# **FINAL (MYO) BASELINE MONITORING REPORT** **SIX RUNS STREAM AND WETLAND MITIGATION PROJECT**

NCDMS Project #100170  
DMS Contract #0303-01  
RFP: 16-20190303 (Issued 12/20/2019)  
USACE Action ID: SAW-2020-01964 | DWR Project #20201798 v1

RE: DMS Comments on the MY0 Report Six Runs, Project ID #100170, DMS Contract #0303-01, RFP 16-20190303

Listed below are comments provided by DMS on July 31, 2023 regarding the Six Runs Stream and Wetland Mitigation Project As-built and MY0 Baseline Monitoring Report and RES' responses.

**Figure 2a**  
Current Conditions Plan View

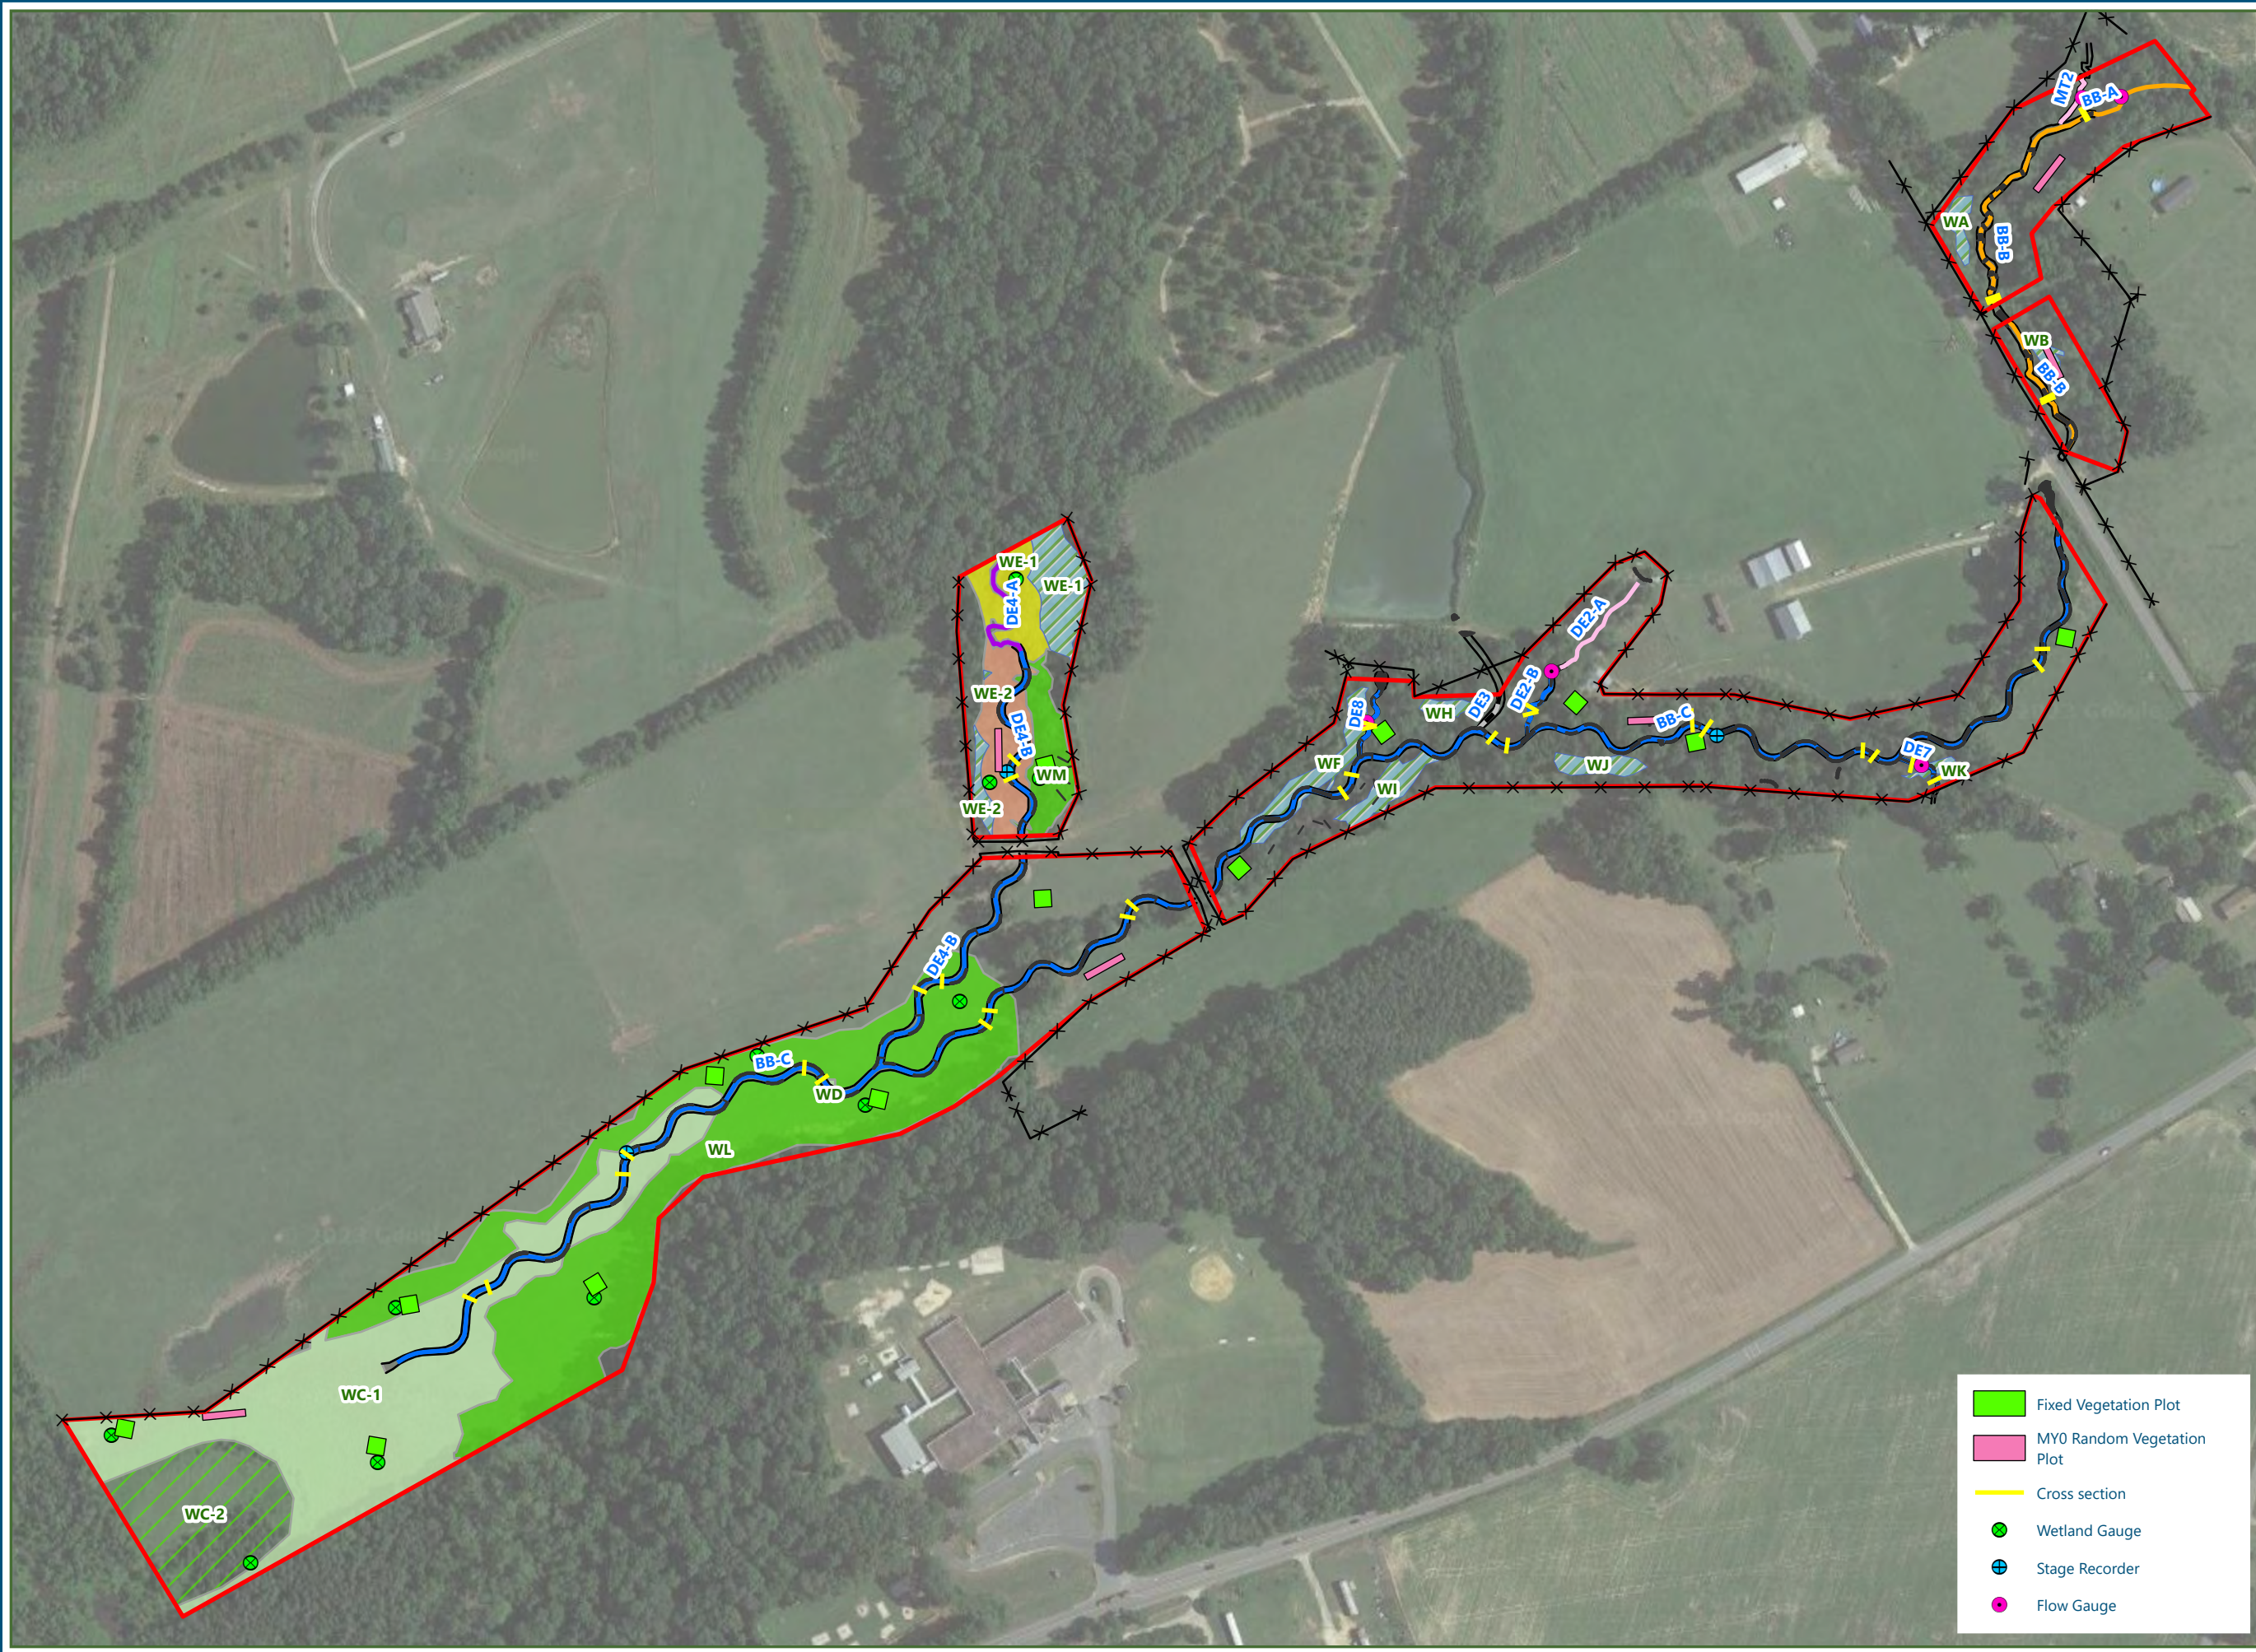
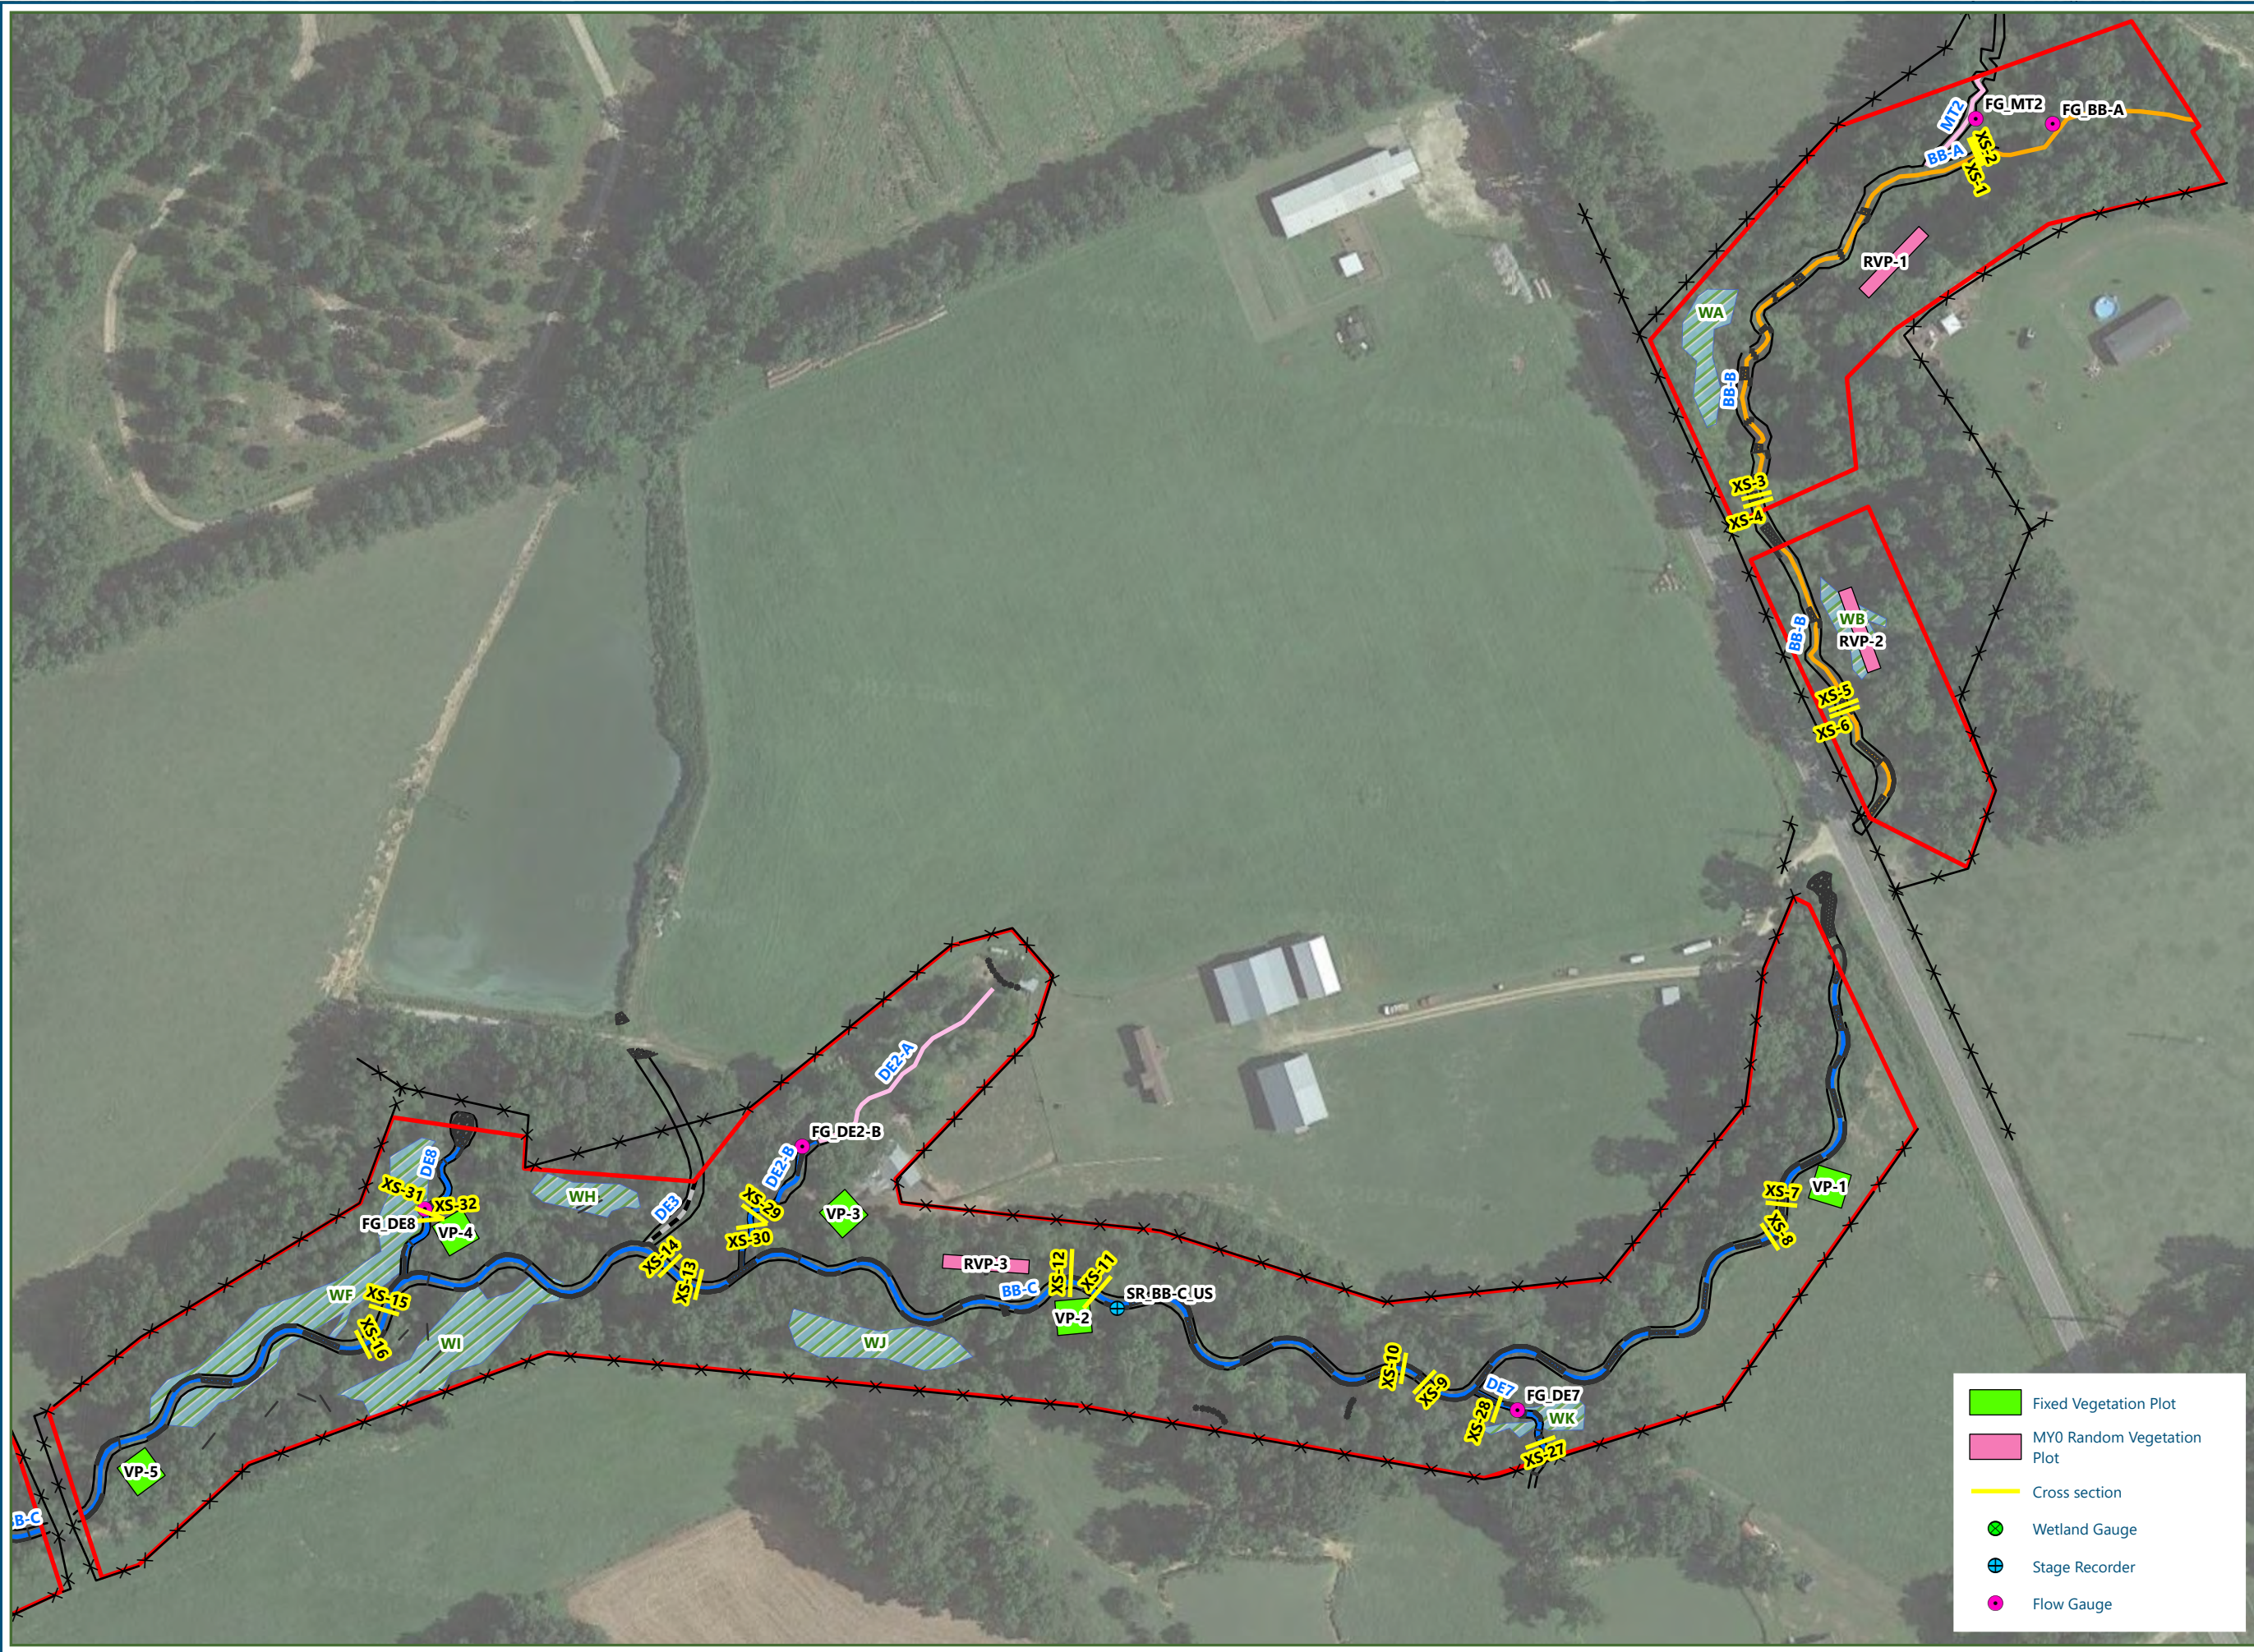
4. CCPV – We recommend re-working the cross-section labeling/line thickness so labels for cross sections 1, 3, 5, 9, and 31 are visible.  
[The cross-section labeling has been revised.](#)
